COUNCIL ASSESSMENT REPORT TO PANEL

SYDNEY EASTERN CITY PLANNING PANEL

PANEL REFERENCE & DA NUMBER	PPSSEC-337 – DA-2024/205
PROPOSAL	BATA 2 - Lot F – Removal of trees, excavation, and construction of three (3) connected buildings of 6-13 storeys comprising two (2) levels of basement car parking, 224 residential units, communal recreational facilities, associated landscaping, and construction of a private road.
ADDRESS	16 Studio Drive Eastgardens (Lot 34 DP 1312041)
APPLICANT	Karimbla Properties (no.39) Pty Ltd
OWNER	Karimbla Properties (no.39) Pty Ltd
DA LODGEMENT DATE	28/08/2024
APPLICATION TYPE	General Development
REGIONALLY SIGNIFICANT CRITERIA	CIV >\$30 million
CIV	\$132,785,999
CLAUSE 4.6 REQUESTS	FSR – 2.97:1
LIST OF ALL RELEVANT PLANNING CONTROLS (S4.15(1)(A) OF EP&A ACT)	<ul style="list-style-type: none"> • State Environmental Planning Policy (Planning Systems) 2021 • State Environmental Planning Policy (Sustainable Buildings) 2022 • State Environmental Planning Policy (Housing) 2021 • State Environmental Planning Policy (Biodiversity and Conservation) 2021 • State Environmental Planning Policy (Resilience & Hazards) 2021 • State Environmental Planning Policy (Transport an

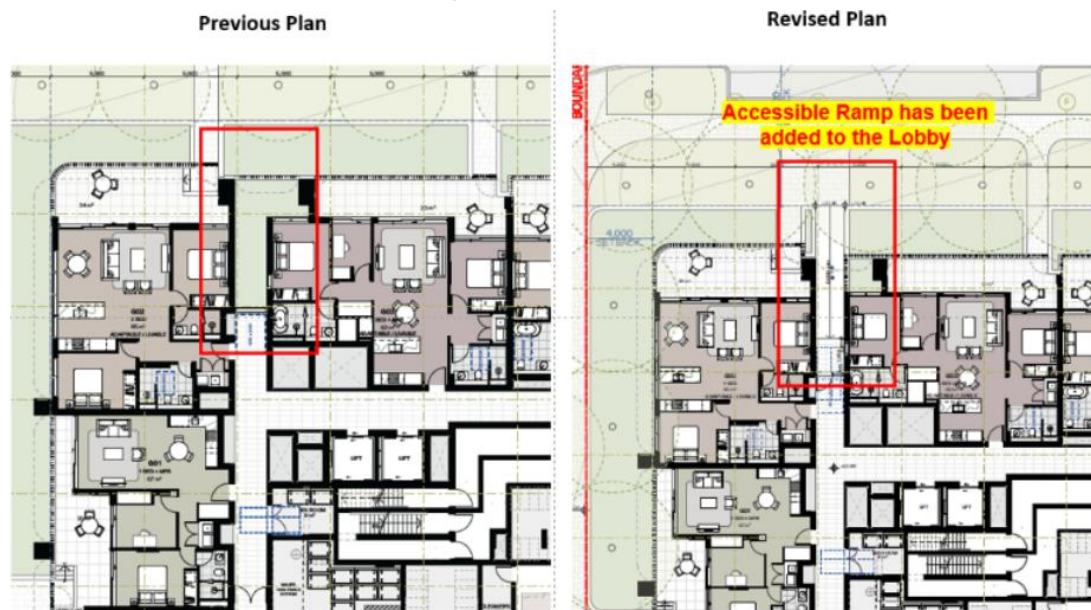
- Relocate solar panels on Level 8 to the roof (L15). This will allow the enlargement of the communal roof terrace on L8.

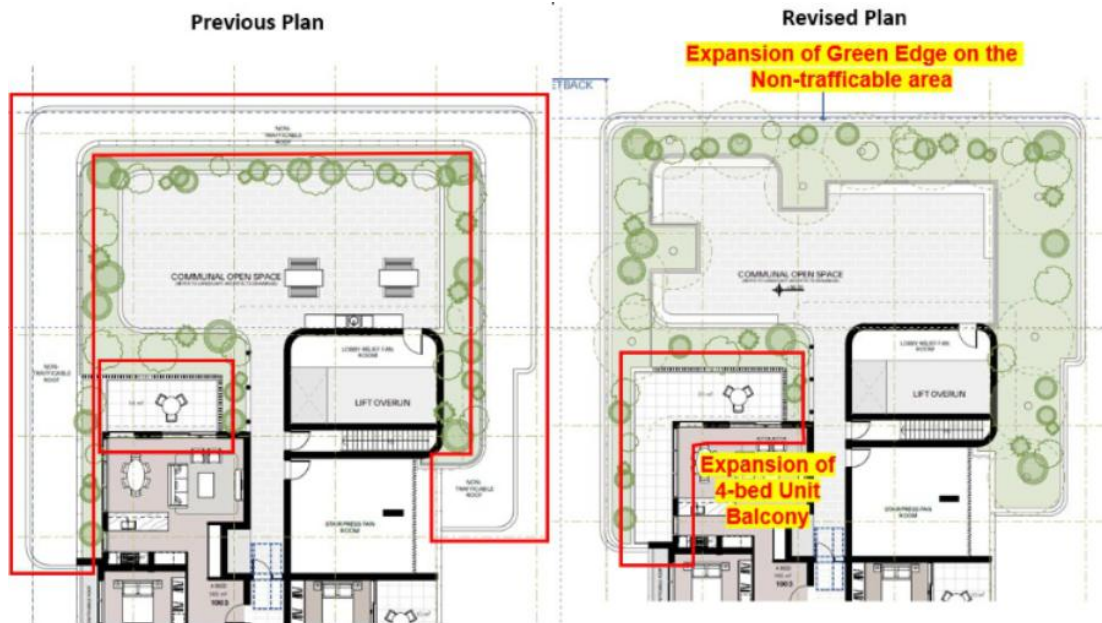
- Add accessible ramp entry into the main lobby from the north (through the gap between unit G02 and G03 if the levels permit).

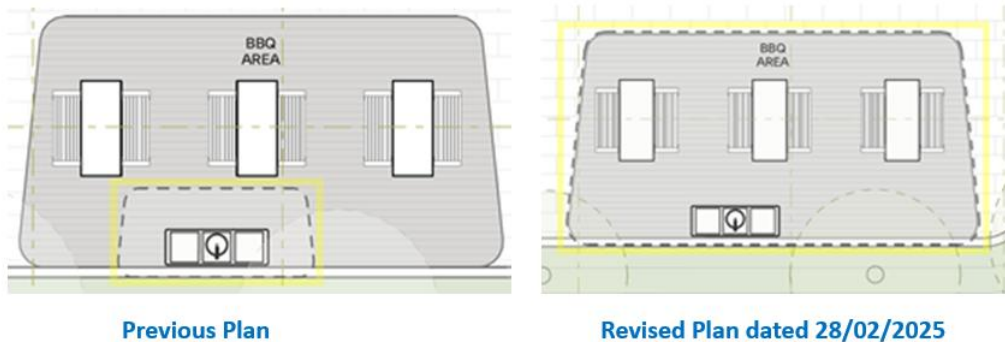
- Balcony of unit 1003 to wrap around the western side of the façade. It could extend into the non-trafficable zone to allow larger balcony depth commensurate with it being a 4-bedroom unit.

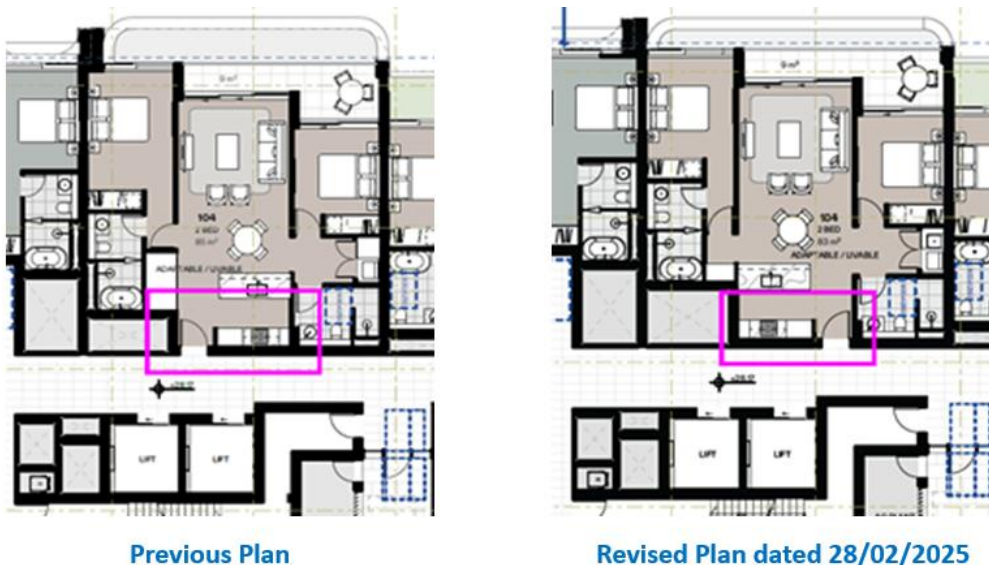
- The pergola's over the BBQ's should cover the adjacent seating area in all instances. The plans show small, dashed areas that only seem to cover the BBQ.

Previous Level 7 Plan

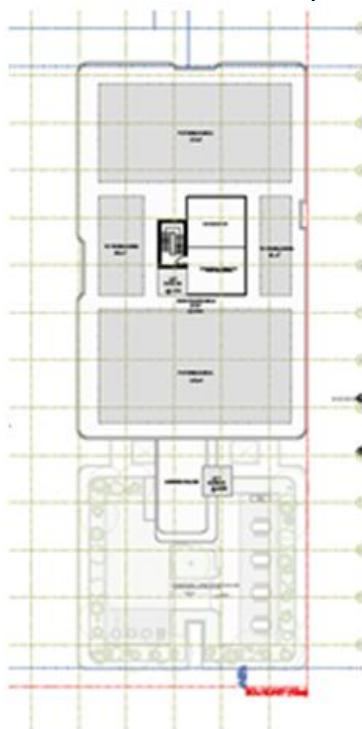
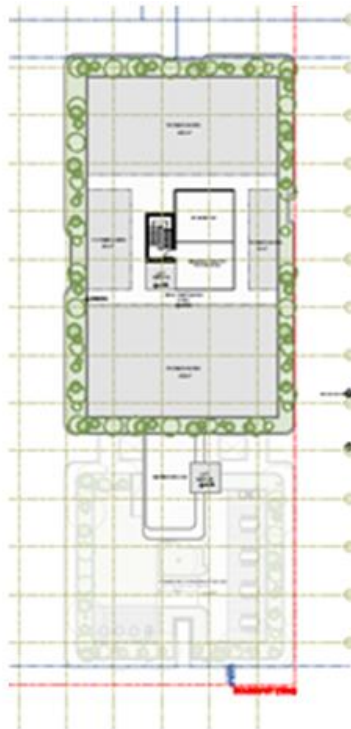
- Provide WC facilities to the communal open space area to Level 6

- Provide a continuous planter of at least 1000mm soil width to achieve a green edge to the rooftop of the eastern tower currently dedicated to solar panels and services to ameliorate visual impact

The applicant has provided a justification for not following this recommendation as below:

As shown above, the amended plans have generally addressed the issues raised by the DRP except for the provision of additional WC facilities in Level 6 communal area. It is noted; however, WC facilities are provided in the communal area at podium level as shown below. The justification by the applicant is accepted in this instance.
